PRODUCT MODIFICATION SUMMARY
7CT1N

INDEX PAGE: 1 TITLE: CURVE TRACER

BYPASS CAPACITORS**Effective Prod SN B050910**

UNUSED CONTACTS REMOVED

Main Circuit Board, 670-1933-00
(Front)

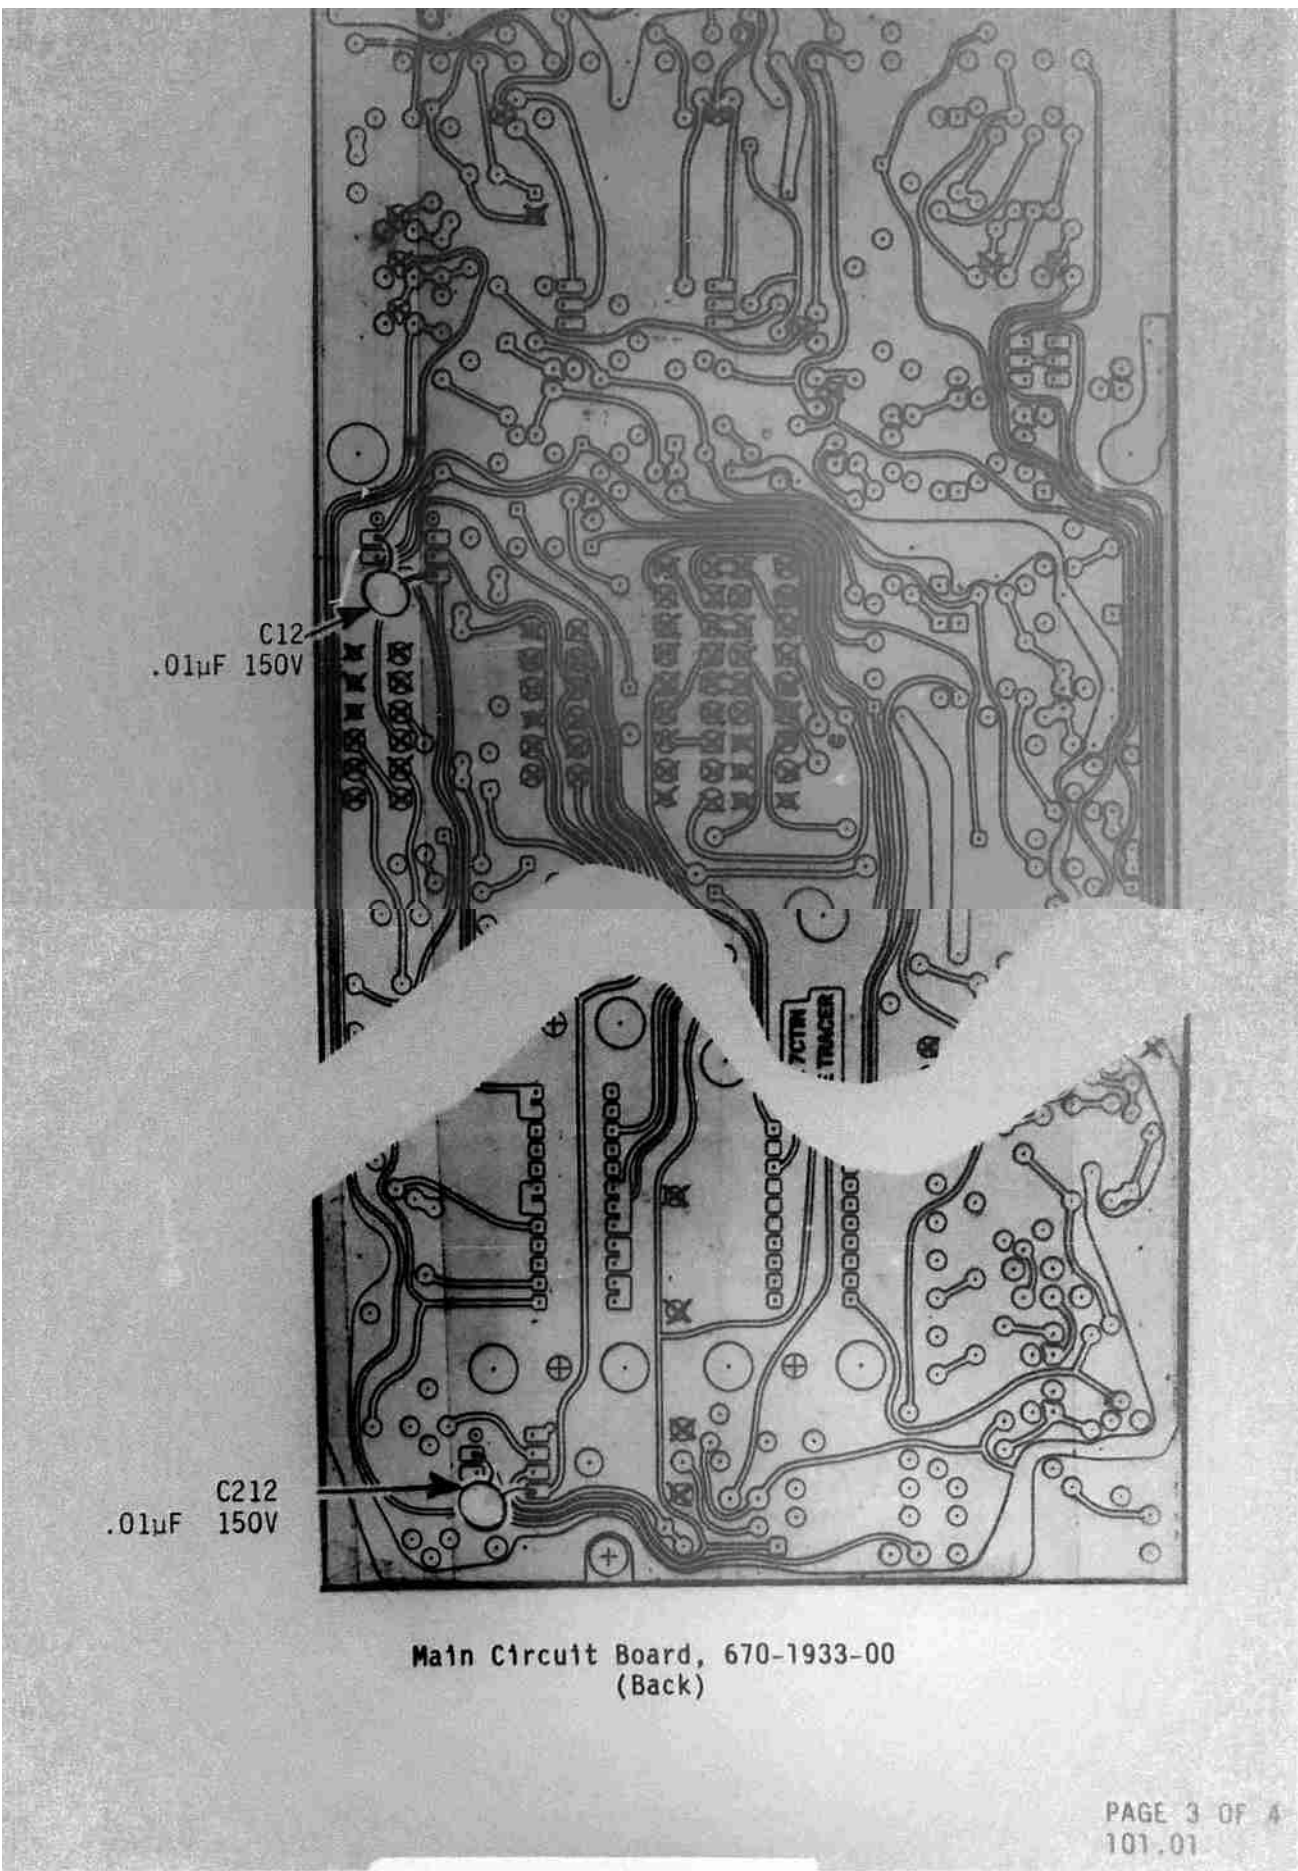
Vertical and horizontal error signals were being generated because of improper bypassing of the Operational Amplifiers, U11, U114, and U194. To prevent these error signals, the following 0.01 μ F bypass capacitors were added:

1. C12 between pins 4 and 7 of U11.
2. C112 between pins 4 and 7 of U114.
3. C212 between pins 4 and 7 of U194.

C12 and C212 were located on the back and C112 was located on the front of the Main circuit board, pn 670-1933-01. See attached drawings for details.

C112
.01 μ F 150V

C12, C112
C212 283-0003-00 Capacitor, cer, 0.01 μ F, -20+80%, 150V

Main Circuit Board, 670-1933-00
(Back)

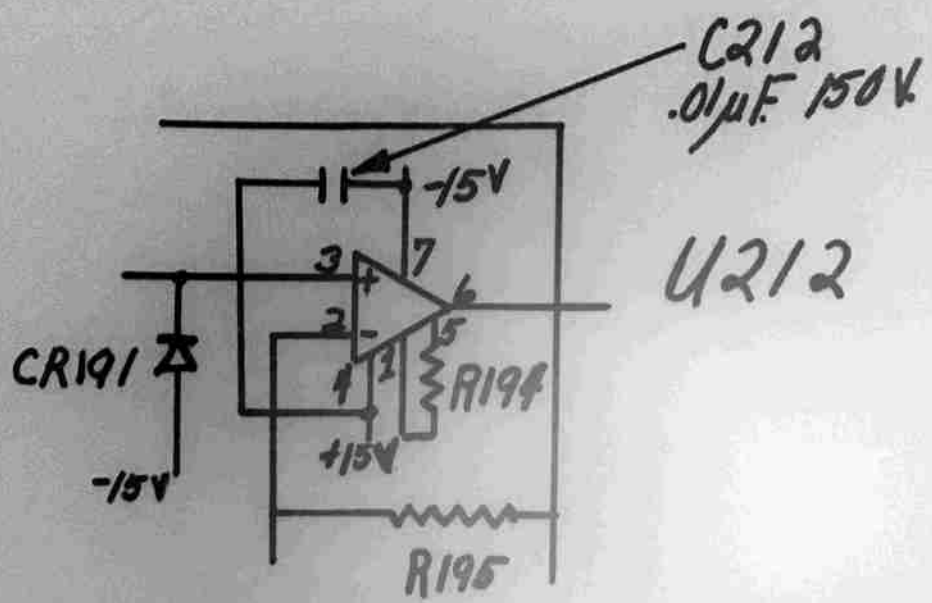
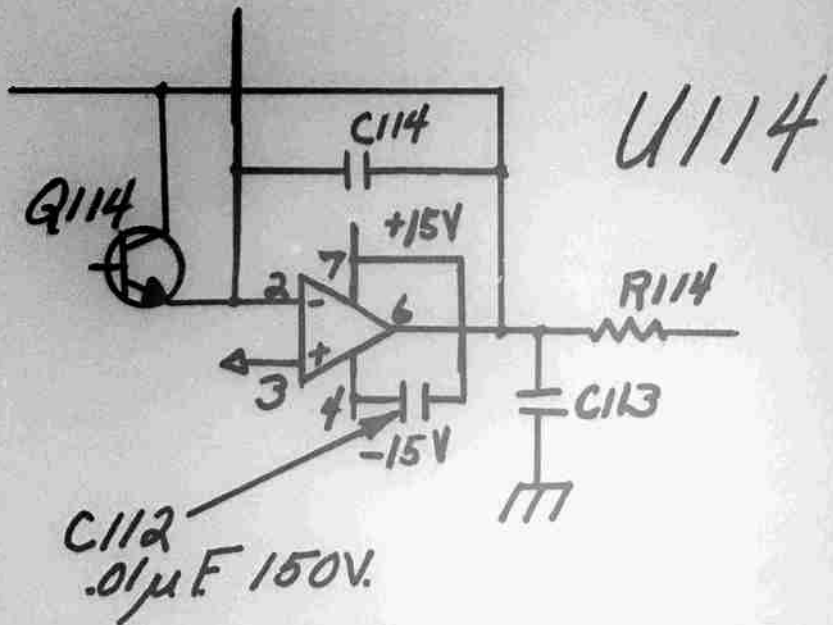
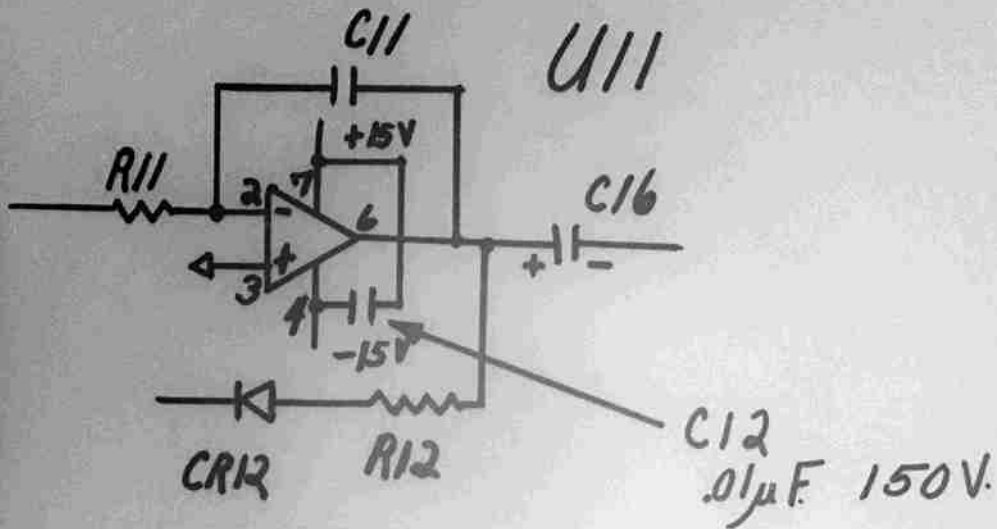
C12
.01 μ F 150V

C212
.01 μ F 150V

TYPICAL CIRCUIT BOARD
(INTERFACE)

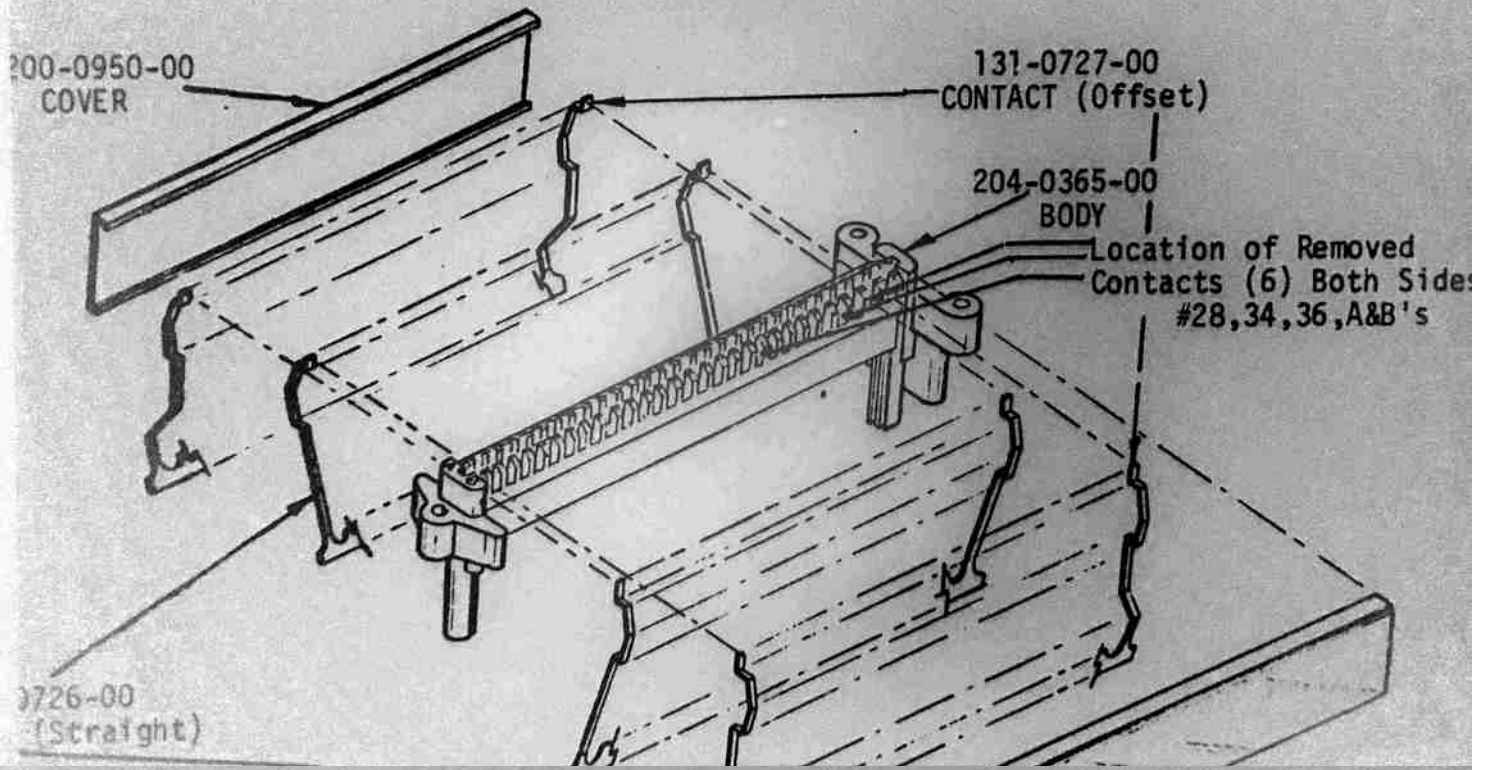
A. TO REMOVE UNUSED CONTACTS FROM PLUG-INS: (Refer to drawing on page 2)

- () 1. Locate contacts 28A & B, 34A & B and 36A & B. Contacts are numbered in ascending order from the bottom to the top. "A" contacts are on the front side of the Interface board and "B" contacts are on the back side of the board.

NOTE: The contacts (Interface board circuit pads) to be removed do not have circuit runs connected to them.

- () 2. Using a sharp knife, pry under the edge of the contact pad and rock the blade back and forth to roll the pad off the board. Heating the pad with soldering iron will help loosen it.

TYPICAL
CONNECTOR, RECEPTACLE, ELEC.
(PLUG-IN CKT. BD.)

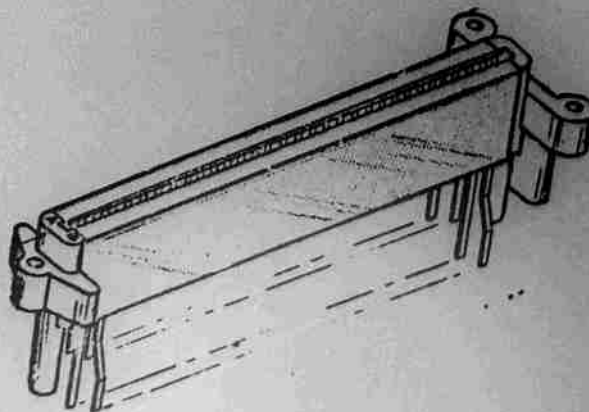
B. TO REMOVE UNUSED CONTACTS FROM MAIN FRAMES: (Refer to drawing on Page 4)

- () 1. Remove the right side and bottom covers.
- () 2. Remove the circuit boards that are mounted on the plug-in side of the main interface connector circuit board to gain access to connectors.

- () 3. Remove the plastic covers* (200-0950-00) from the plug-in connectors using tool PN 003-0718-00. Or as an alternative, use the flat blade of a small screw driver and carefully pry off each cover by starting at one end and proceeding across in steps, releasing a small portion with each step. Be sure to pry against the edge of the cover only to avoid breaking off the plastic fingers that separate the contacts.

- () 4. Remove contacts 28A & B, 34A & B, and 36A & B as follows:
 - a) With a pair of needle nose pliers, unclip the contact from the connector.
 - b) Grasp the contact with the needle nose pliers and unsolder the contact from the main interface circuit board with a miniature soldering iron (15 watt).

- () 5. To reinstall the connector covers, set the back edge of the cover in place, then snap the front edge in place, beginning at one end and proceeding to the other end in zipper fashion keeping back edge in place as you proceed.
